UNITED STATES PATENT AND TRADEMARK OFFICE

APPLICATION NO.	FILING DATE	FIRST NAMED INVENTOR	ATTORNEY DOCKET NO.	CONFIRMATION NO.
10/041,789	01/08/2002	Hans-Walter Bielefeld	BIELEFELD	4601

Office Action Summary	Application No. 10/041,789	Applicant(s) BIELEFELD ET AL.	
	Examiner Yvonne M. Horton	Art Unit 3635

Fig.2

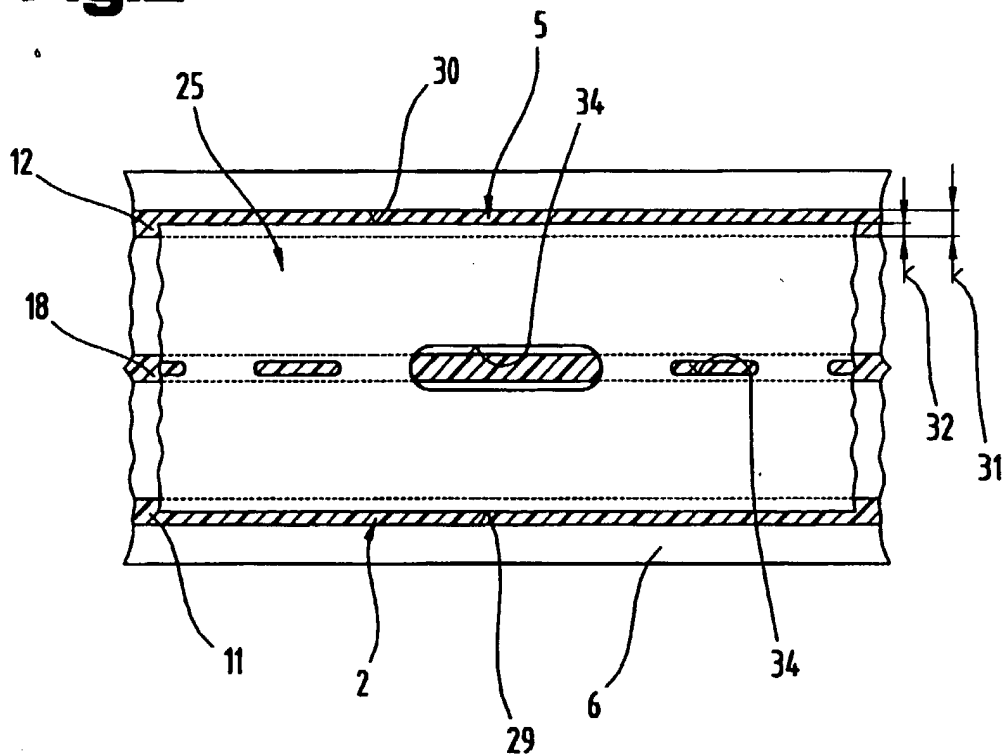
Regarding claim 12, the punchings R open outwardly and are offset one longitudinal side 29,30 by a between area A, see the marked attachment, such that the punchings R on opposing sides 29,30 are in a same area.

Regarding claim 24, the stiffening element has longitudinal sides 29,30 and punchings 34 formed in an area between the longitudinal sides 29,30, see Figures 2 and 3.

Fig.3

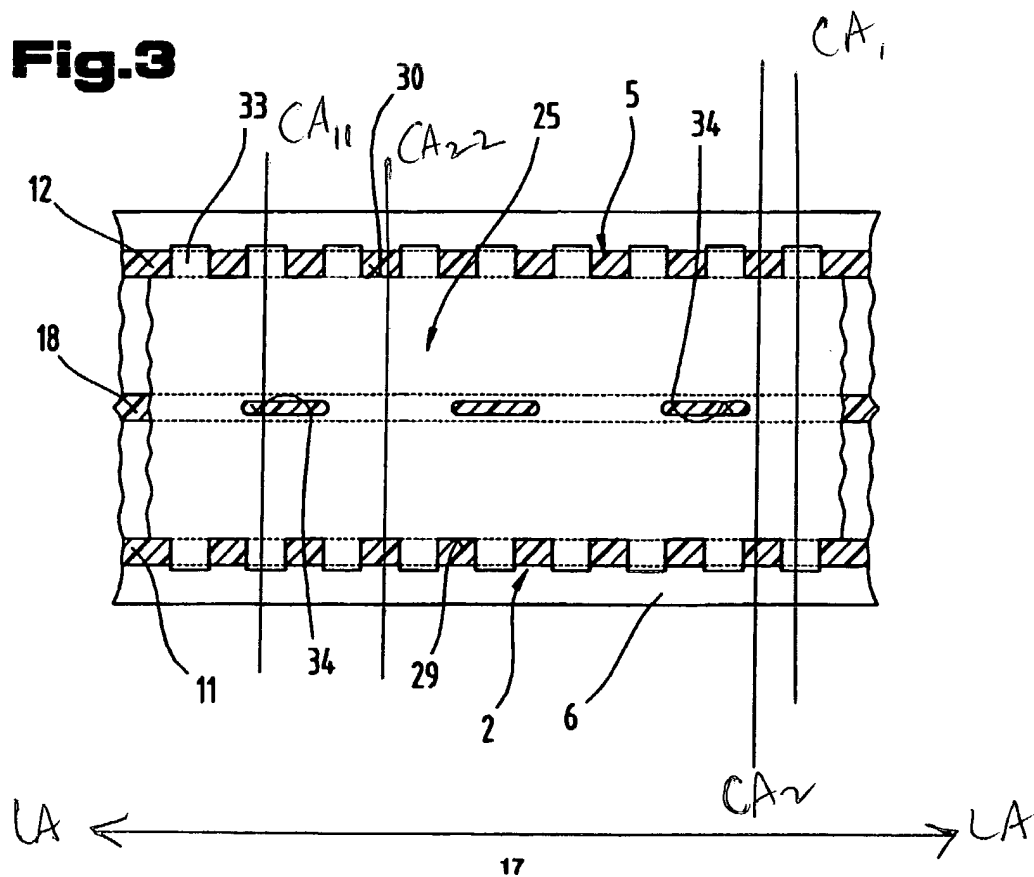
Regarding the applicant's argument that the cross-section of the stiffening elements does not include punchings such that the stiffening element has the same cross-section throughout, the Official Actions details two separate embodiments of stiffening elements of EP 0 828 052, figures 3 and 15. The applicant in his response details that claim 1 relates to "identical cross-sections at different locations and does not relate to a symmetric cross-section at one location. The first embodiment as shown in figure 3 has the same cross-section at different locations (CA1) and (CA11) throughout, and also has the same cross-section at different locations (CA2) and (CA22) throughout. Also, the second embodiment as shown in figure 15 has the same cross-section (CA,68) at different locations throughout. Hence, both embodiments of figures 3 and 15 of stiffening member 25 clearly have the same cross-section throughout (i.e. from longitudinal side 29 to longitudinal side 30).

Fig.2**Fig.3**

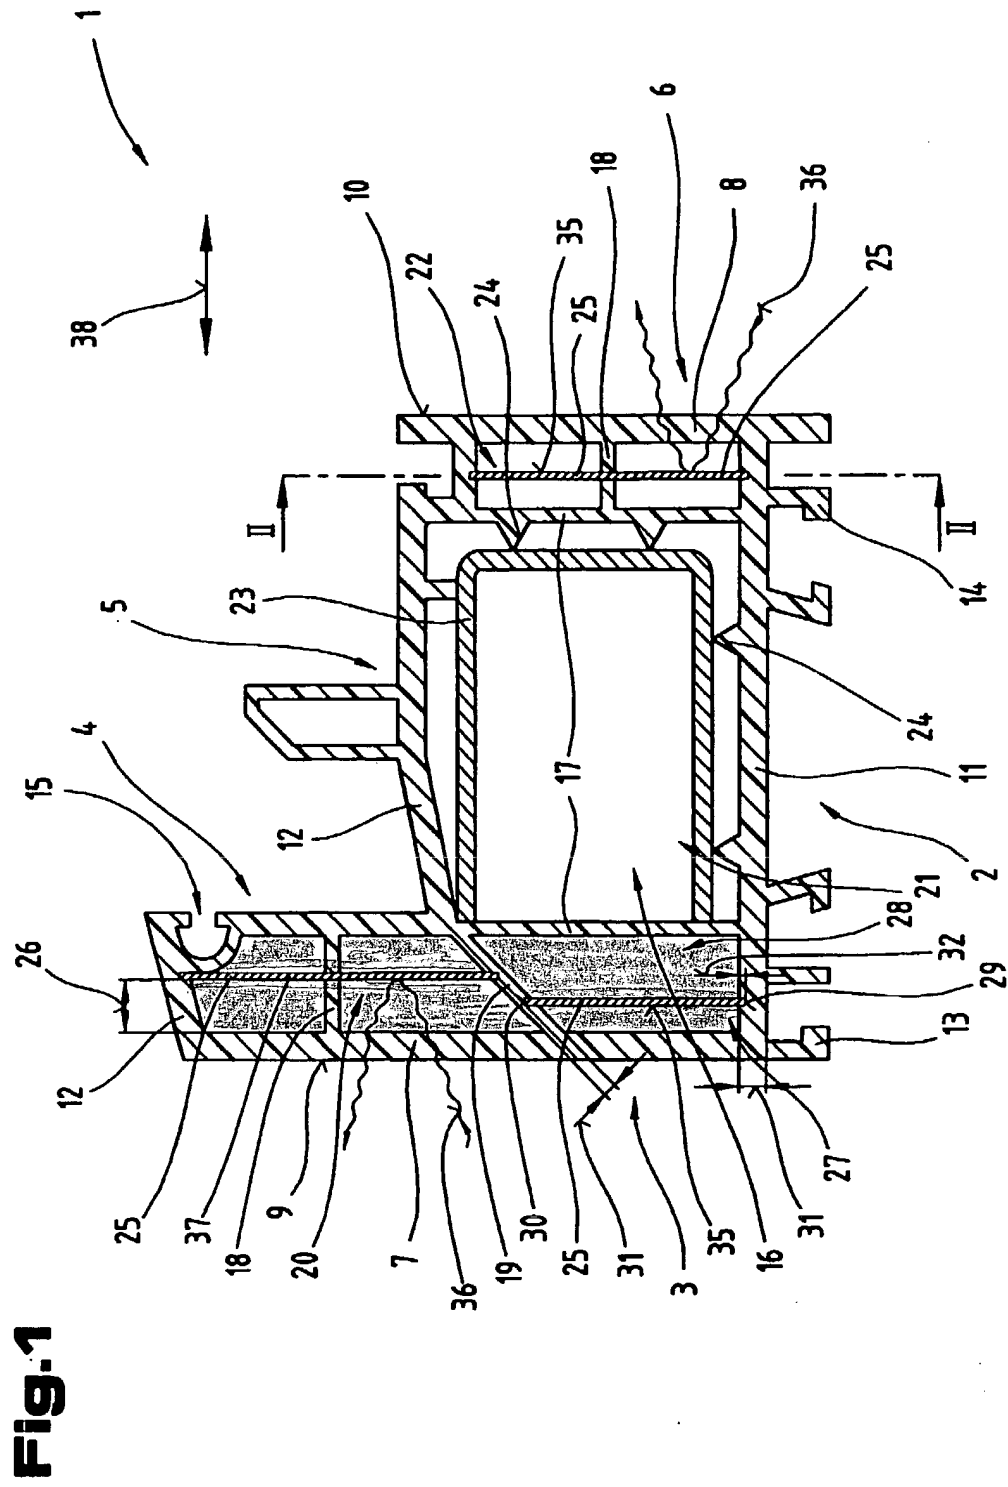
Regarding claims 18 and 19, the strip-shaped stiffening elements 23,25,52 have lateral boundary planes (colored red in the marked attachment) that do not intersect any visible surfaces 9, 10 of the frame section 1; wherein the stiffening elements 23,25,52 have sufficient distance (colored green in the marked attachment) to the visible surfaces 9, 10 of the frame section 1 such that the end zone of the stiffening elements 52 "can inherently be" worked on
